RIDEM, RIDOT & Utility Submission

1300 Hartford Avenue
Johnston, Rhode Island

DEPARTMENT OF ENVIRONMENTAL MANAGEMENT
OFFICE OF WATER RESOURCES
FRESHWATER WETLANDS PROGRAM
APPROVED WITH CONDITIONS
AS SPECIFIED IN THE LETTER OF APPROVAL
DATED NOV 27 2019 FILE # 19-0205
NO CHANGES ALLOWED WITHOUT PRIOR APPROVAL
APPROVED PLANS MUST BE AT CONSTRUCTION SITE

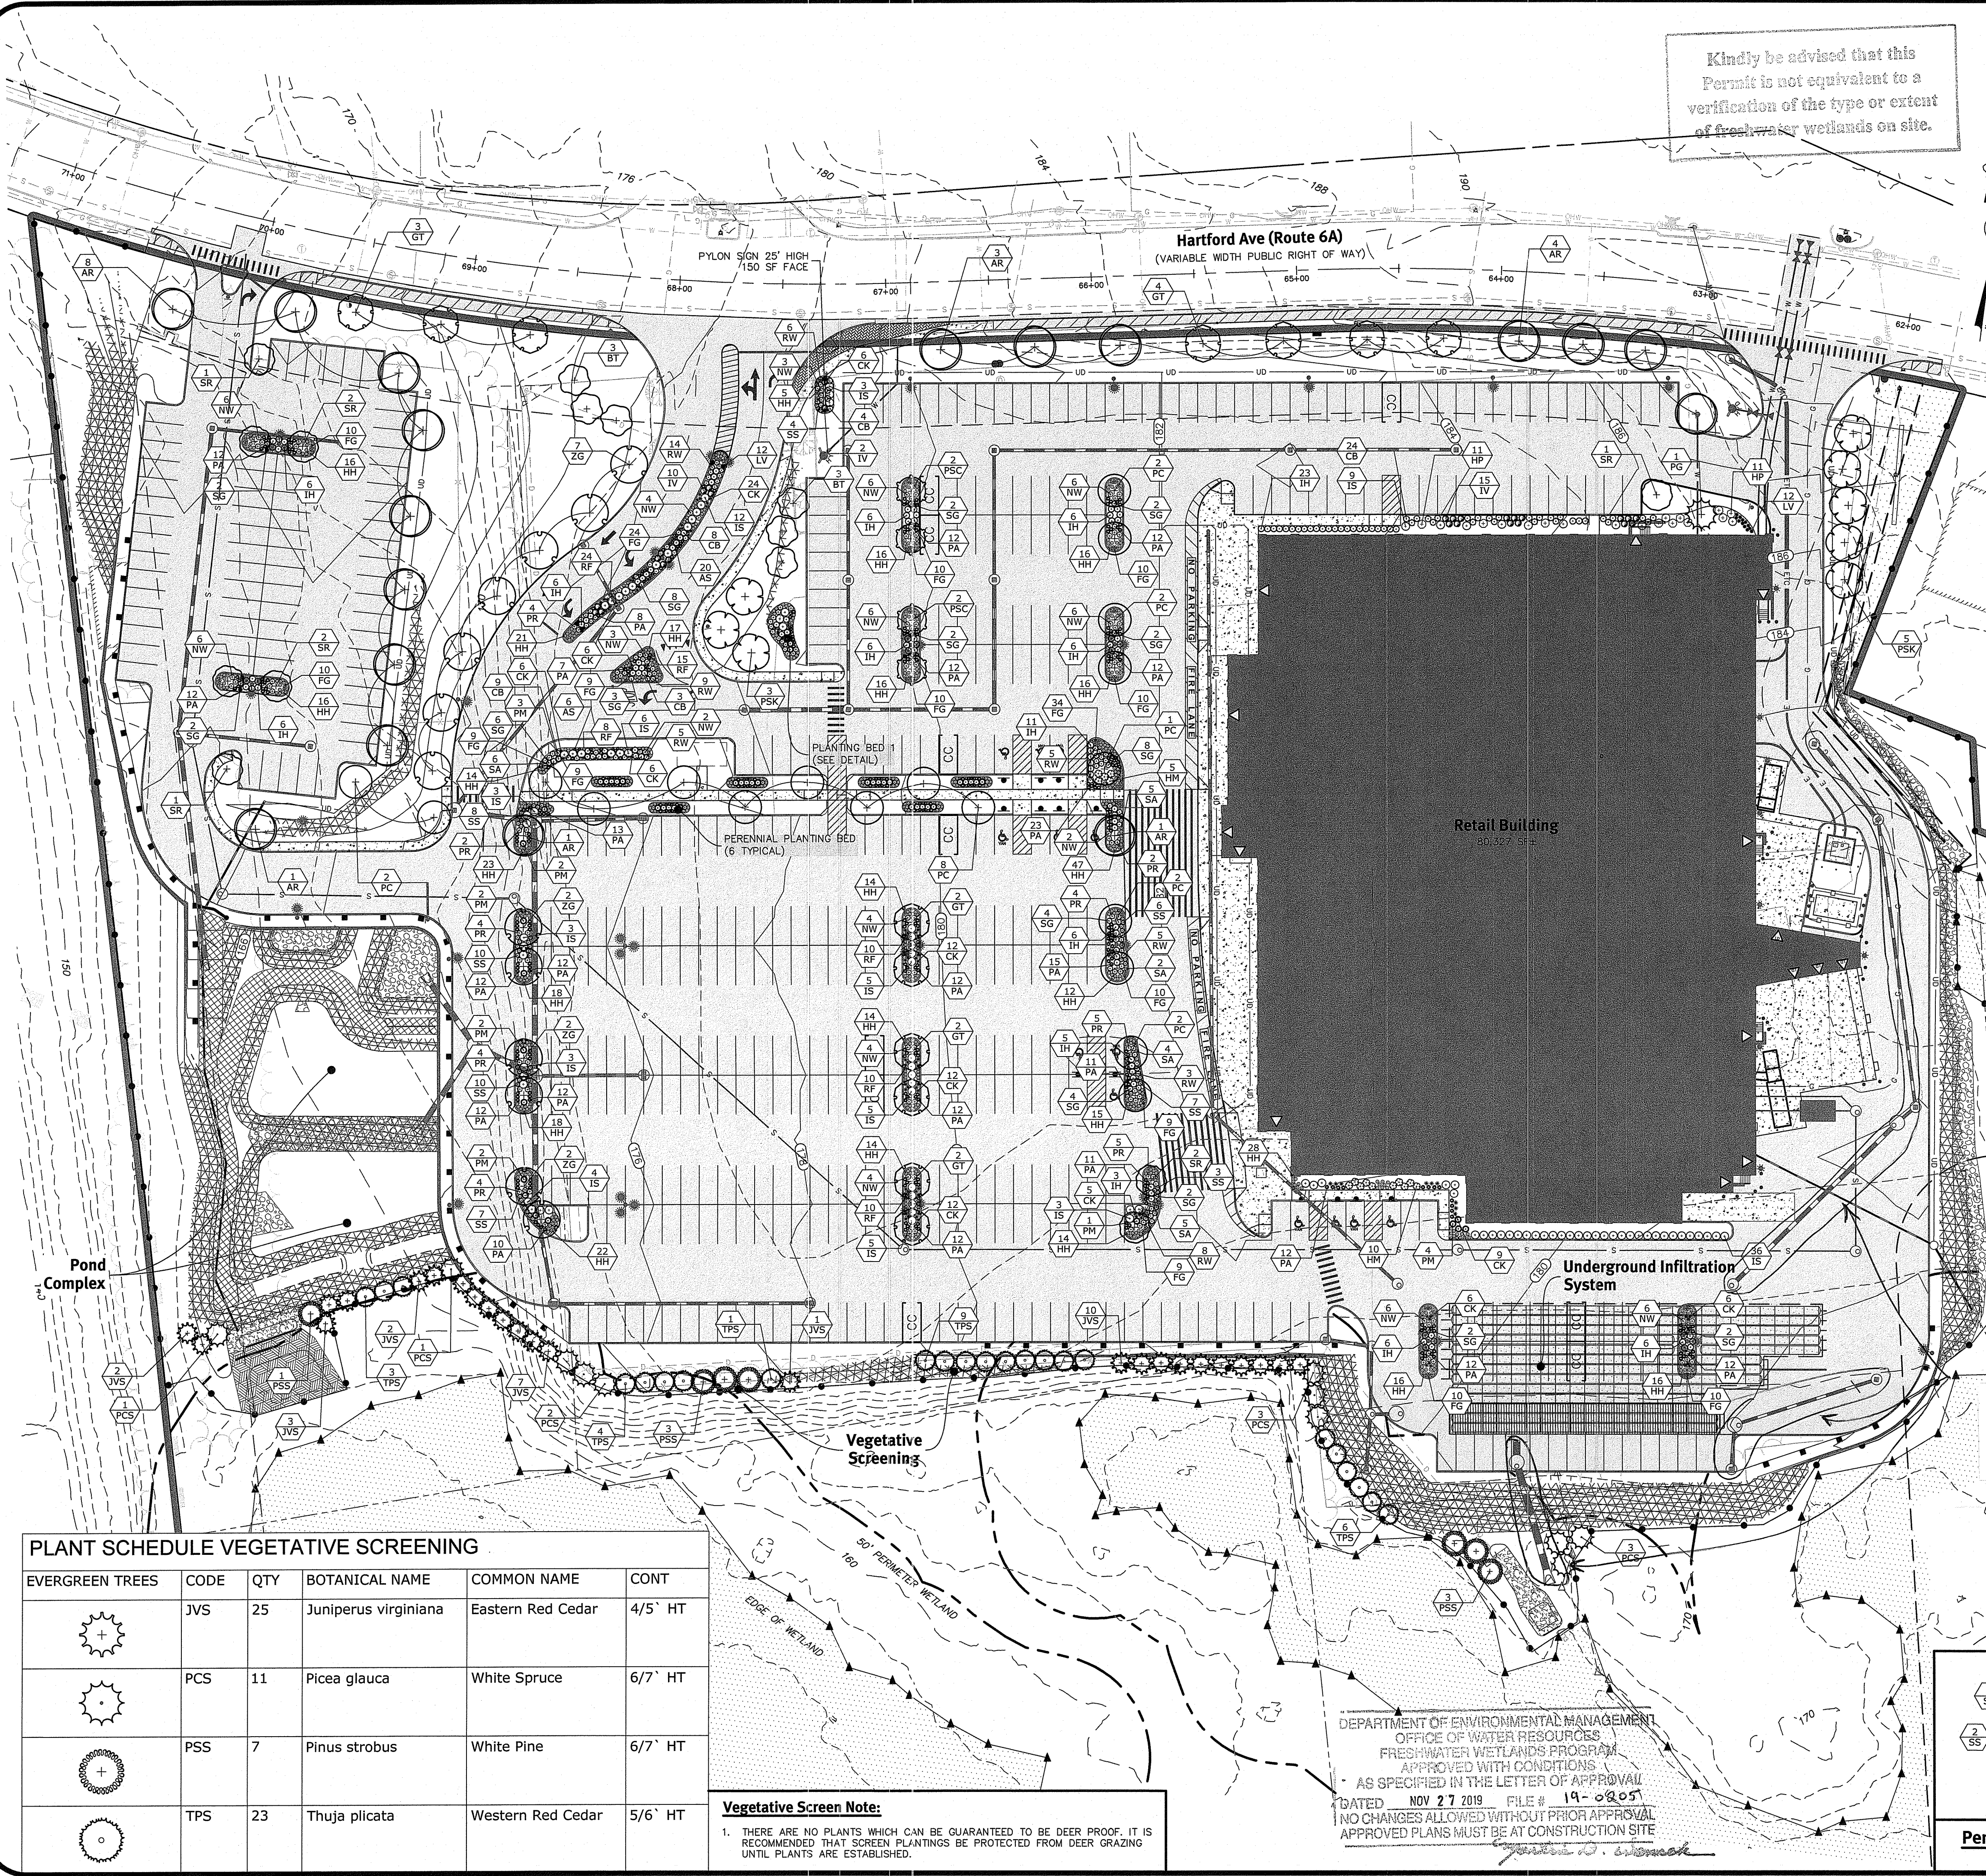
These drainage pipes/culverts are erroneously depicted on this site plan which are not consistent with the authorized design. Sheet 18 of 19 as approved by DEM is solely for landscaping purposes.
